ACTION TRANSMITTAL No. 2013-34

SUBJECT: Scope Change Request for Bridge No. 9 over the Mississippi River at the University of Minnesota

REQUESTED ACTION: The City of Minneapolis requests a scope change to modify the scope of the Bridge No. 9 project over the Mississippi River to Pier 3 concrete repair and installation of full height concrete encasement.

RE: TE-09-13 - Bridge No. 9 (MnDOT 94246)
Bridge 9 over the Mississippi River Substructure Rehabilitation
and Superstructure Painting Scope Change
SP 141-090-038

ELEVATION

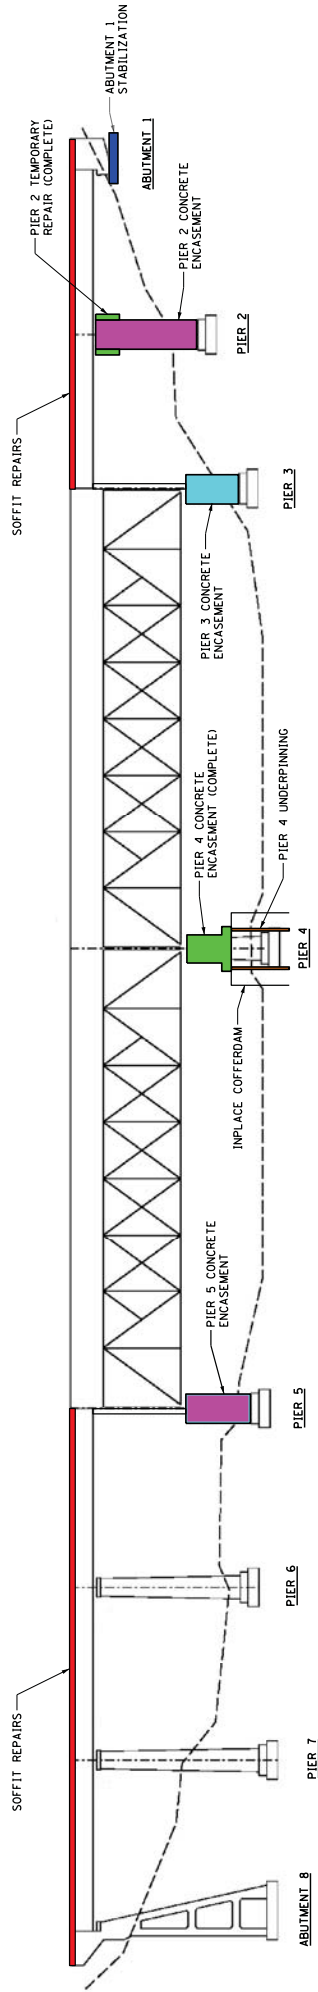
The City directed ONE to develop repair plans to address the critical finding. Emergency repairs were immediately initiated to address pier & bearing support conditions at Pier 4 (river pier) and Pier 2 (see attached Elevation Plan for pier locations) to allow pedestrian traffic to remain on the bridge. This work was completed by City of Minneapolis forces in fall & winter of 2012 and 2013. The cost of the work exceeded \$700,000.

The repairs required at Pier 4 and Pier 2 are more extensive than the anticipated in the 2009 report. Concrete encasement was provided at Pier 4 from the top of cofferdam to the pier cap to prevent truss bearing support failure. A post-tensioned steel clamping fixture was installed at Pier 2 to accomplish the same objective. Additional work is necessary at both piers to complete these repairs. At Pier 4 a deep foundation system is needed to underpin the concrete encasement. At Pier 2 concrete encasement is required for the full height of the pier column to provide a permanent solution.
